Item 5.**Development Application: 86 Foveaux Street, Surry Hills - D/2019/412****File No.:** D/2019/623**Summary****Date of Submission:** 26 April 2019

Amended 25 October 2019

Applicant: Ms Penelope Benton**Architect/Designer:** Sarah Gilder**Owner:** Ms Penelope Benton**Cost of Works:** \$324, 500**Zoning:** The site is located within the B4 Mixed use zone, the development is permissible with consent.**Proposal Summary:** The application proposes alterations and additions to the existing building including a second floor addition, landscaped roof terrace, repairs to a balcony onto Corben Street, and Strata Subdivision of the site into 2 lots and common property.

Figure 10: Area taken to be included as 'site area' for the purposes of FSR

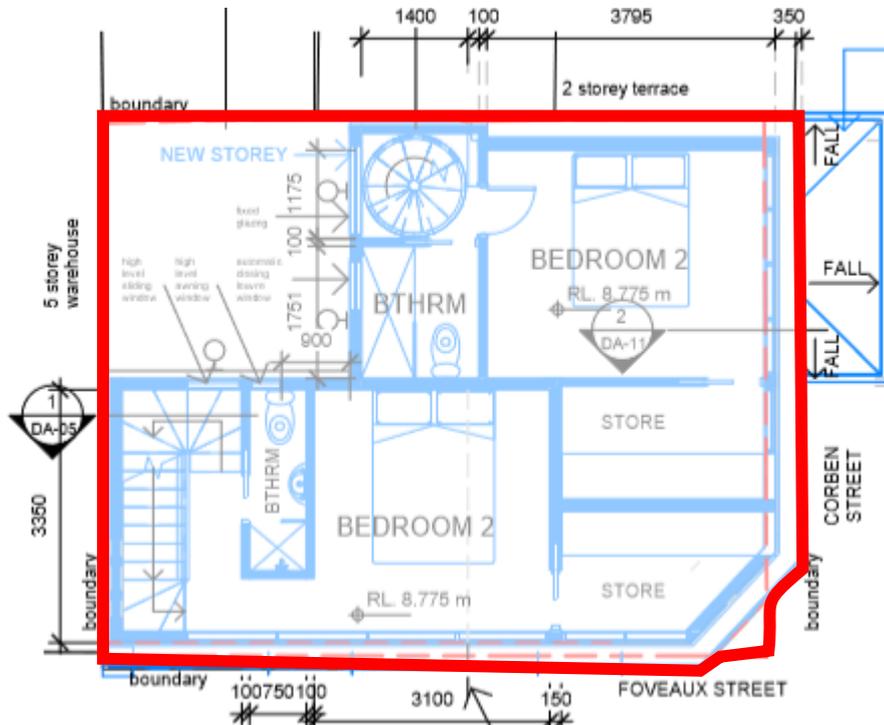
26. The submitted floorplans demonstrate that the existing facades of the building have been built beyond the site boundaries along Foveaux Street and Corben Street. For the purposes of calculating FSR these facades have been included within the site area (see figure 10 below). As such, the site is taken to have an area of 64sq.m.

27. Sydney LEP controls specify a maximum FSR of 1.75:1. Given the site area, this equates to a maximum of 112sq.m of Gross Floor Area (GFA). The proposed GFA comprises;

28. The proposal would exceed the maximum GFA by 29 sq.m which equates to 25.9%. The proposed development would have an FSR of 2.2:1.

Figure 10: Proposed Section

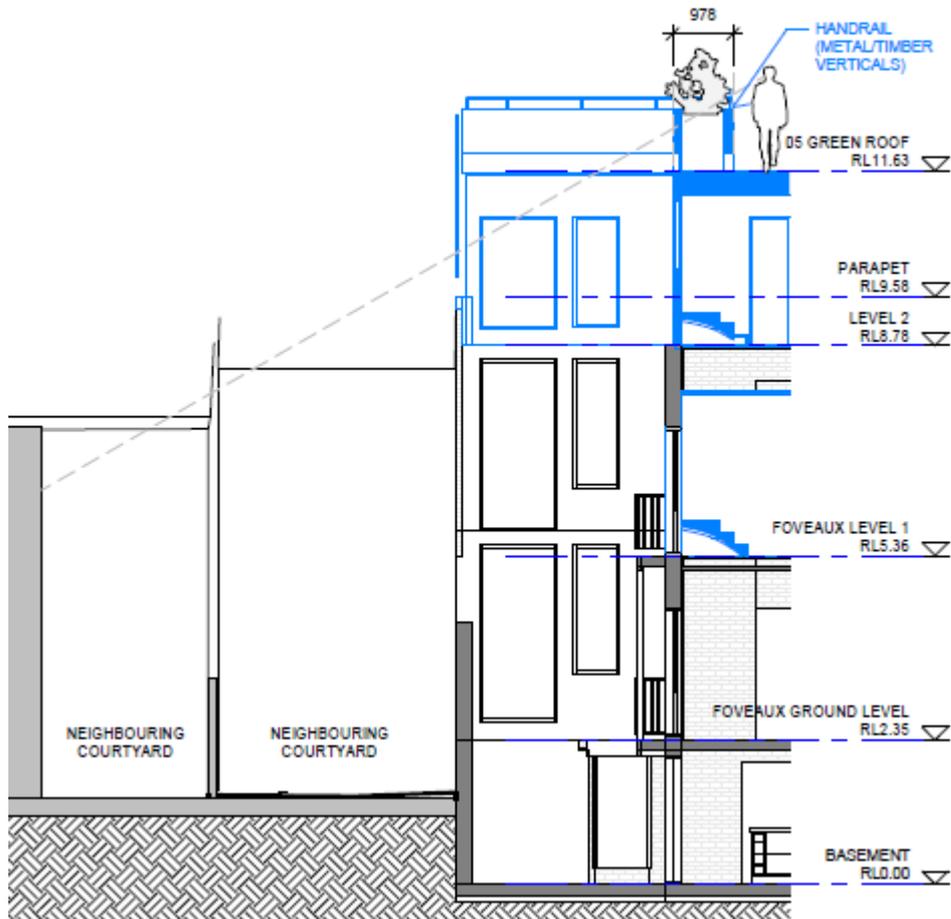
44. The proposed landscaped roof would be communal space, accessed by both residential units on site. With the exception of an access stair to 'Terrace 2', the majority of the trafficable area would be set back from the north boundary of the site by 1.5m. The spiral access stair would be used momentarily and is not considered to result in a loss of privacy to neighbouring properties.
45. Perforated metal cladding would screen the northernmost part of the roof from neighbouring properties. The applicant has demonstrated that the proposed screening, and setback, in addition to the height of the landscaped roof, would prevent any overlooking into the rear windows or open spaces at both 41 and 43 Corben Street.

46. Conditions are recommended to ensure that the screening and set-back is maintained in-situ for the lifetime of the development. Subject to conditions, the proposal would comply with part 4.1.3.6 of the DCP.
